IR2020-4 Biofilm and Effects to Migratory Birds

In his letter of August 24, 2020,¹ the minister of environment and climate change (the minister) requested the Vancouver Fraser Port Authority (the port authority) provide additional information regarding avoidance and other mitigation measures, including technically feasible project design options, to avoid or reduce effects to fish and fish habitat. In the following responses, the port authority has provided additional information regarding the feasibility of on-site design changes, from an engineering design and constructability standpoint, as well as other considerations:

Figure IR2020-4-1: Various statistical expressions of salinity during the freshet period under future conditions with reduced project footprint (Scenario 1)

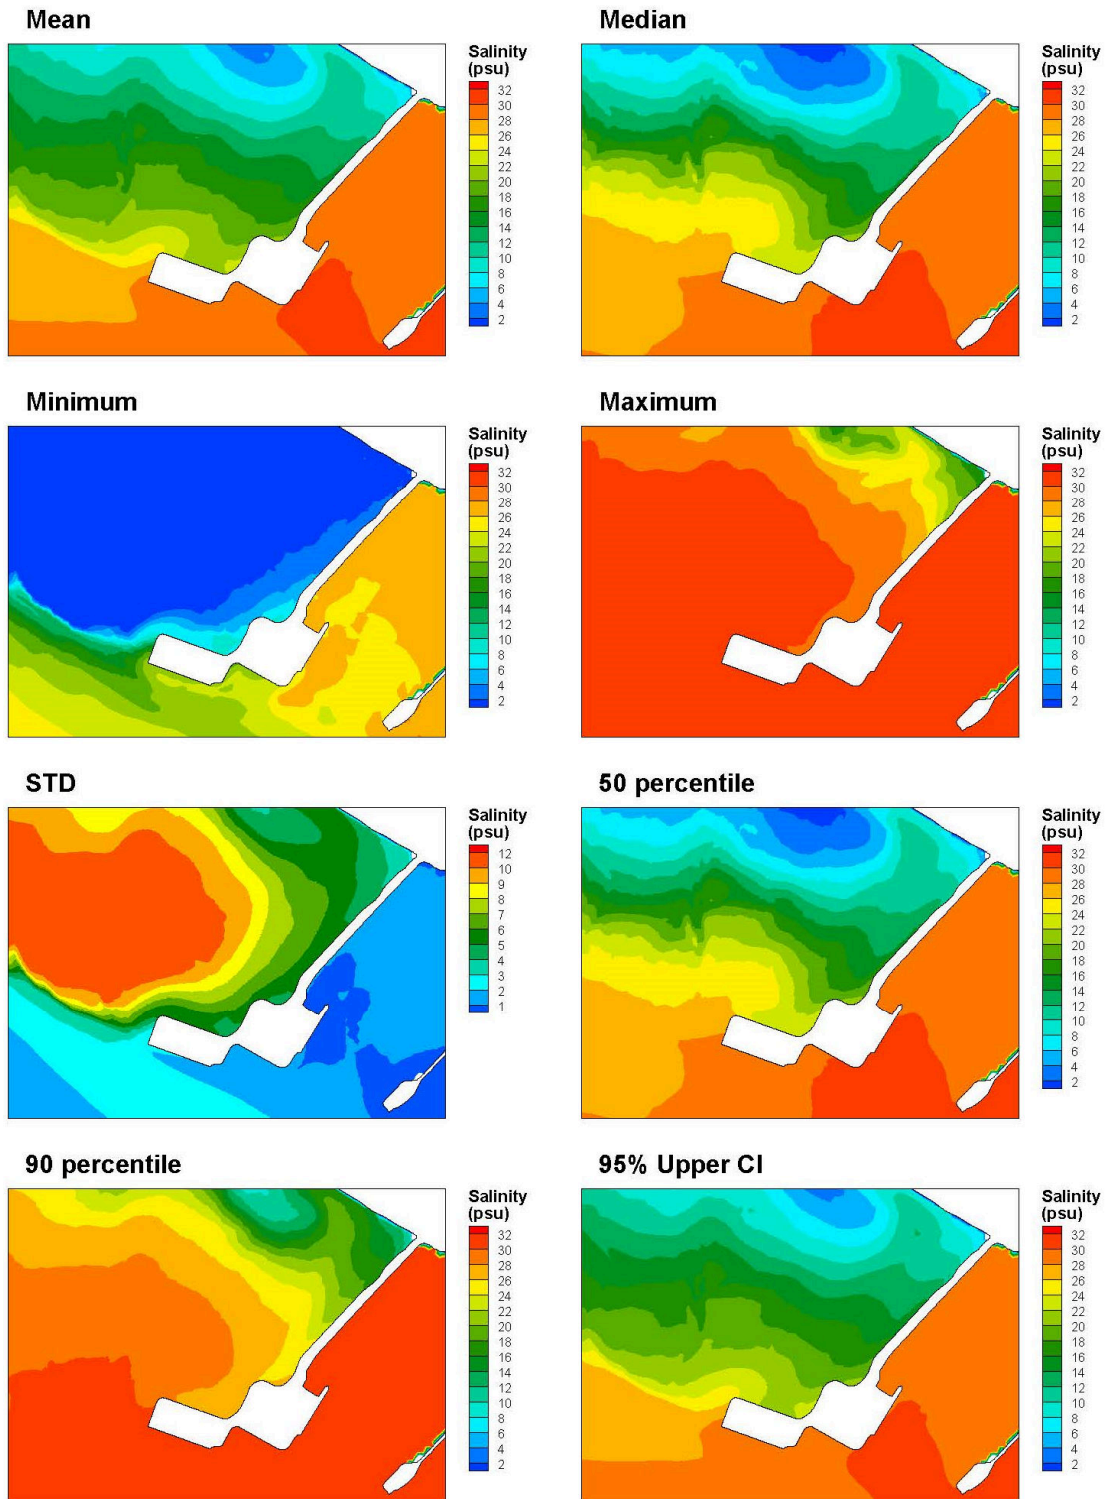
- show statistical summaries of predicted salinity changes, including mean, median, minimum, maximum, standard deviation, 90th percentile, 95 Upper Confidence Limits for Means for the range of current salinity concentrations, and the predicted changes with the alternate project designs. These summaries shall be predicted under both freshet and non-freshet conditions;
- present results as in Table IR-02-3 and related figures, and using the spatial extent shown in Figures 9.7-3, 9.7-4, 9.7-9 and 9.7-10 in Section 9.7 of the Environmental Impact Statement;

Table IR2020-4-1 summarizes the statistical expressions of salinity that have been requested. This summary is similar to that which was provided in the response to IR2-02,⁴ and is provided here for clarity.

Table IR2020-4-2 provides a summary of model runs and the corresponding figure numbers where the results are presented. For the purposes of responding to this part of the minister’s request, results from modelling of Scenario 1 are presented, as the changes to salinity associated with the causeway breach (Scenario 2) are too small to be visible at the requested scale. Therefore, **Figure IR2020-4-1** to **Figure IR2020-4-4** reflect the expected salinity changes in the future with the project for Scenario 1, which are essentially indistinguishable from the expected salinity changes in the future with the project for Scenarios 2 and 3. As discussed below, **Figures IR2020-4-15** and **IR2020-4-16** provide a comparison of the change in salinity for freshet and non-freshet periods, respectively, that was previously predicted for the EIS reference concept design to that predicted for Scenario 1.

Figure IR2020-4-5: 50th percentile salinities associated with the freshet period under future conditions with reduced project footprint (Scenario 1)

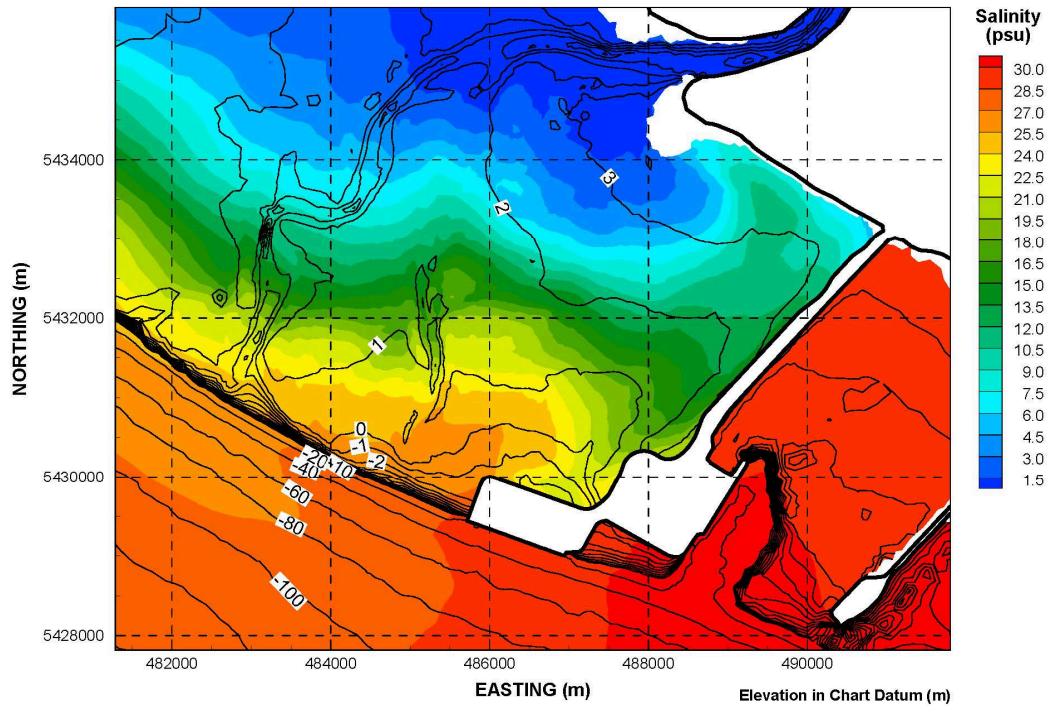
- characterize the magnitude, geographic extent, duration and frequency of any change in the salinity regime;

With respect to the magnitude, geographic extent, duration, and frequency of change in the salinity regime, **Figure IR2020-4-5** and **Figure IR2020-4-6** show the 50th percentile salinity for the reduced project footprint (Scenario 1) during the freshet and non-freshet periods, respectively. **Figure IR2020-4-7** and **Figure IR2020-4-8** show the difference between the 50th percentile salinity for existing conditions (EIS Appendix 9.5-A Figure 74 and Figure 76) and Scenario 1 (**Figure IR2020-4-5** and **Figure IR2020-4-6**) during the freshet and non-freshet periods, respectively. These difference results are essentially indistinguishable from those presented in EIS Appendix 9.5-A Figure 78 for the freshet period, indicating that the 14.4 ha footprint reduction would not measurably change salinity. A comparison to a previously submitted figure describing changes with the EIS reference concept design during the non-freshet period is not available in the EIS.⁷

Figure IR2020-4-15: Predicted change* in 50th percentile salinities associated with the freshet period comparing the EIS project reference concept design predictions with Scenario 1 predictions

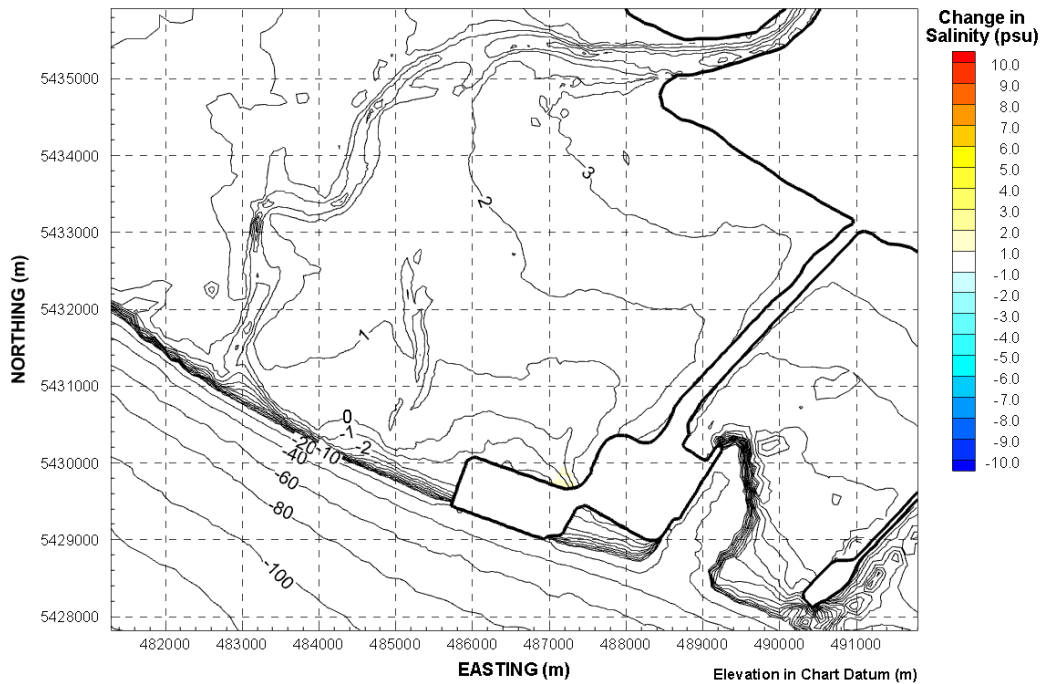
- **describe the relative difference in measured change in the salinity regime (as described in the bullets above) to the current design option and the other design alternatives under consideration;**

As demonstrated above, the relative differences in predicted salinity changes between Scenarios 1, 2, and 3 are extremely small to non-existent, due to the relatively insignificant amount of flow that is exchanged across either of the potential breach locations (causeway or marine terminal) compared to the overall volume of water exchanging over the tidal flats. Similarly, despite the reduction in the project footprint by 14.4 ha, the modelled change to salinity during the freshet and non-freshet periods compared to the existing conditions is essentially the same as that predicted for the EIS reference concept design (as shown in the EIS and reiterated in IR2-02 for the freshet period). The comparisons shown in both **Figure IR2020-4-15** and **Figure IR2020-4-16** are between the predicted changes for the project reference concept design and Scenario 1 configuration for the freshet period and non-freshet periods, respectively.

These results are expected. The anticipated change to salinity at Roberts Bank is primarily related to the change in direction of tidal currents induced by the project, which is largely a function of the length of the proposed terminal. The marine terminal footprint reduction that is being considered (approximately up to 10.3 ha along the north side of the marine terminal) will reduce the terminal width (by approximately 67 m) but not the overall length of the terminal. As a result, the footprint reduction would not appreciably change the magnitude or direction of tidal currents, as compared to the project reference concept design that was evaluated for the EIS.
